**County Board Agenda Item
Meeting of September 26, 2009**

SUBJECT: SP #402 SITE PLAN AMENDMENT to modify conditions pertaining to vacation and encroachments, Columbia Pike Site Frontage, sidewalk and design improvements, sanitary sewer main improvements and water main improvements of the Penrose Square project, located at 2501 9th Rd. S. (RPC #25-016-012, -013, -014)

4 PARKING SPACE OPTION
(For Illustrative Purposes Only)

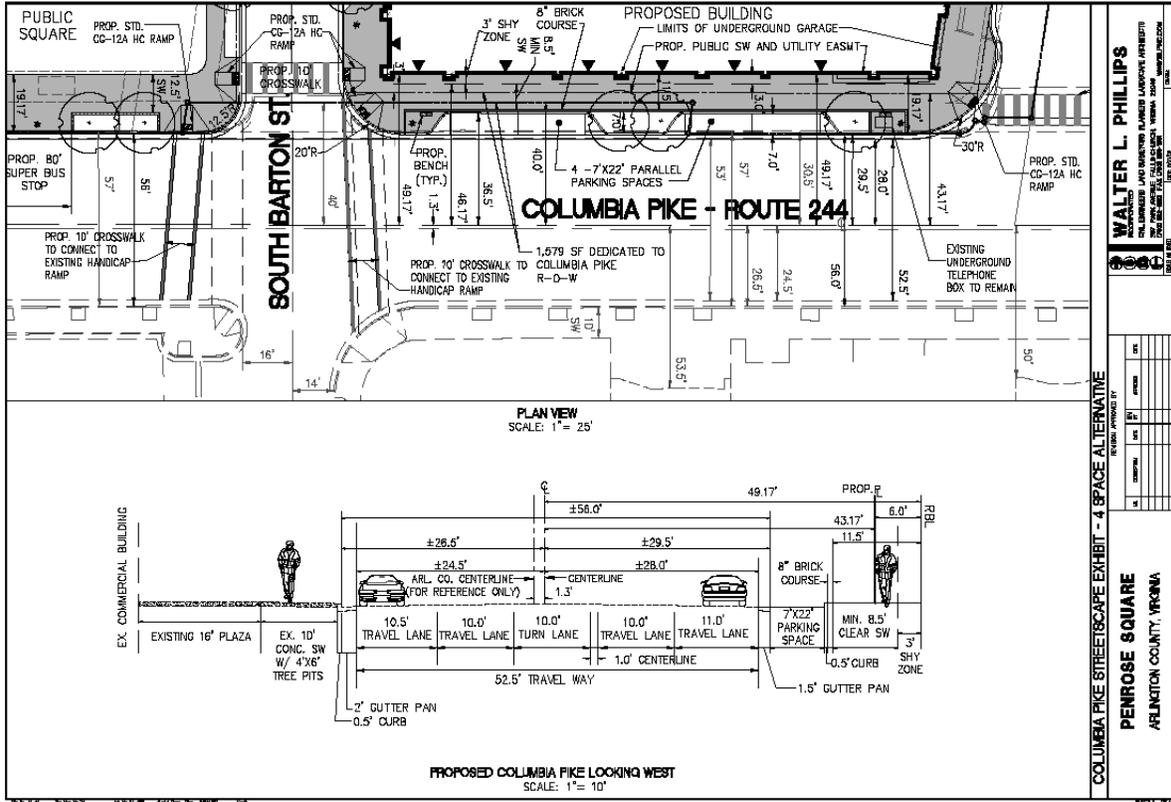
Option 1 shown here retains the two separate 7-foot wide parking bays with two parking spaces in each bay, as was originally approved. While this option provides the parked car buffer for pedestrians, convenient on-street parking and “friction” intended to induce motorists to maintain lower speeds that were envisioned in the Task Force Report, it results in a narrower streetscape. Here, an approximately 12-foot wide sidewalk would be provided measured from the RBL to the back of the tree pit, with a pinch point of 11-feet, 2-inches in the areas of the parking bays. In this option, streetscape furnishings (lights, benches, trash receptacles, etc.) would also need to be placed within this approximate 12-foot wide zone.

COMBINED PARKING BAY OPTION

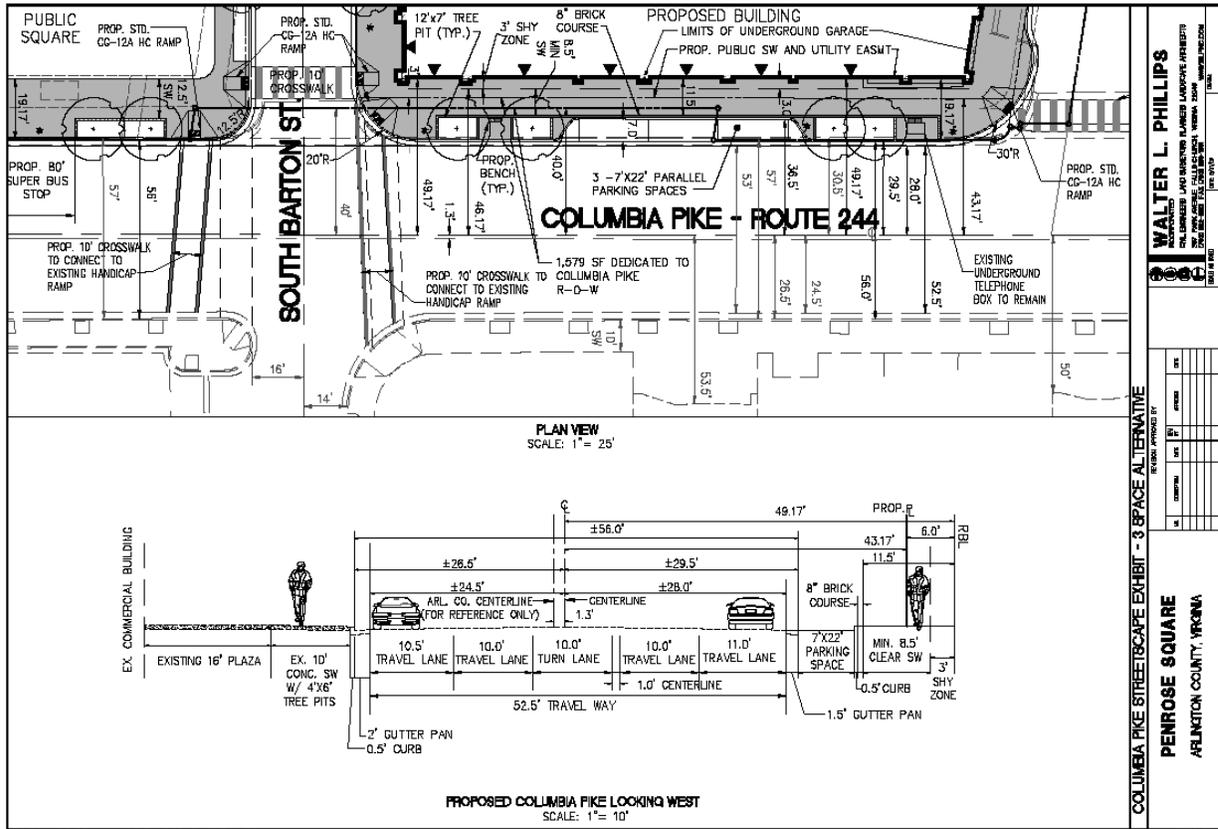
Option 2 consolidates the parking in the center of the block frontage and provides three (3) parking spaces in a single bay, representing a loss of one space. This option also provides a sidewalk that is approximately 12-feet wide measured from the RBL to the back of the tree pit with a pinch point of 11-feet, 2-inches in the area of the parking bay. The consolidated parking allows for two 7-foot wide furniture zones, one at each end of the block. The consolidated mid-block parking provides for simplified parking movements and efficient merging into traffic. The on-street parking introduces “friction” that acts to calm vehicle traffic. This option also provides additional sidewalk area for streetscape furnishing, street trees and lighting.

Based on evaluation and consideration of the advantages and disadvantages of the three options, staff recommends Option 2 and that the site plan be amended to consolidate on-street parking between South Adams and the proposed South Barton Street along the Columbia Pike north-side frontage, with 56 feet from face of curb to face of curb, an approximate 12-foot sidewalk measured from RBL to back of curb, and minimum 6-foot by 12-foot tree pits. This option is the best alternative to preserve the benefits of on-street parking while increasing sidewalk width and area.

COLUMBIA PIKE STREETSCAPE EXHIBIT - NO PARKING ALTERNATIVE

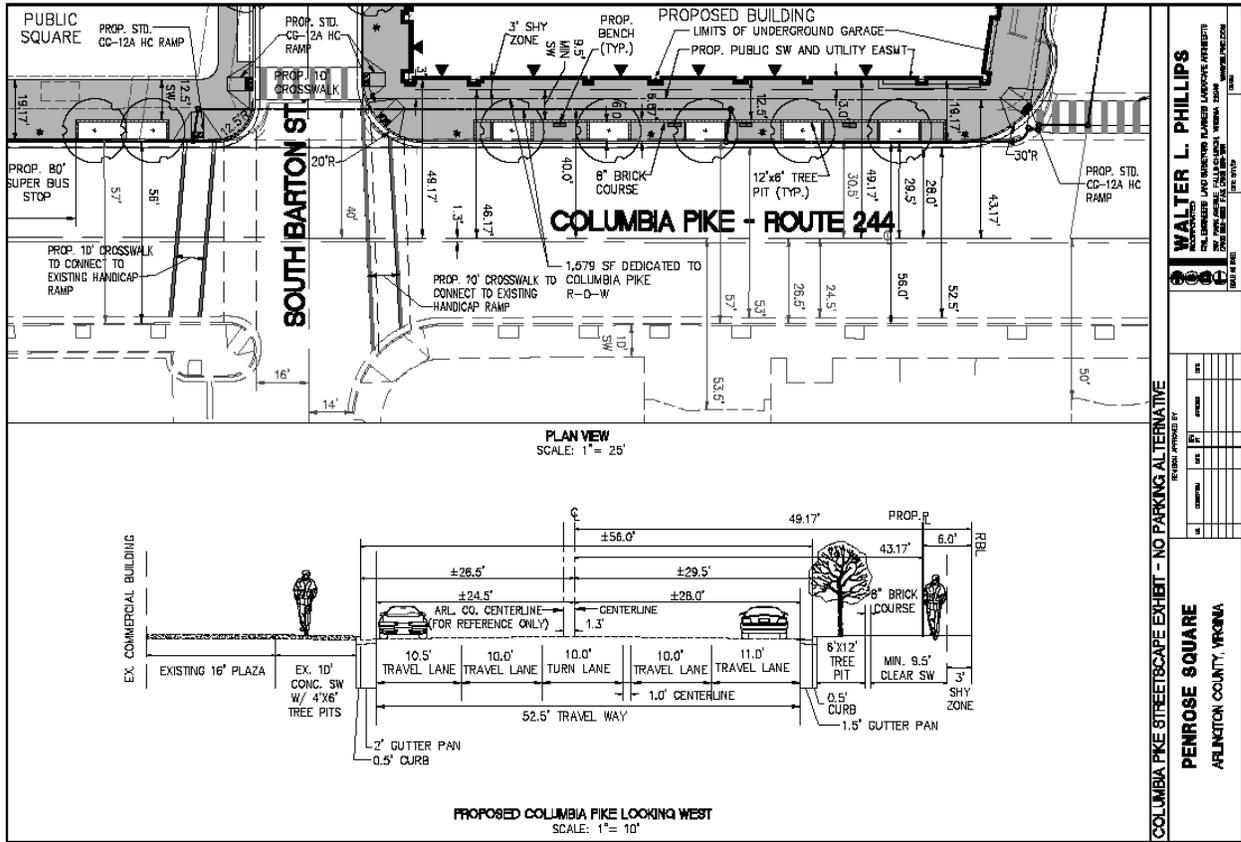
Option 3 eliminates parking along the Columbia Pike frontage. While the advantages of the three or four on-street parking are lost, this option provides for a consistently wider streetscape frontage. The sidewalk is approximately 13-feet wide measured from the RBL to the back of the tree pits with pinch points of approximately 12-feet. This option allows for more street trees and additional space for street lights and streetscape furnishings such as benches, bike racks and trash receptacles.
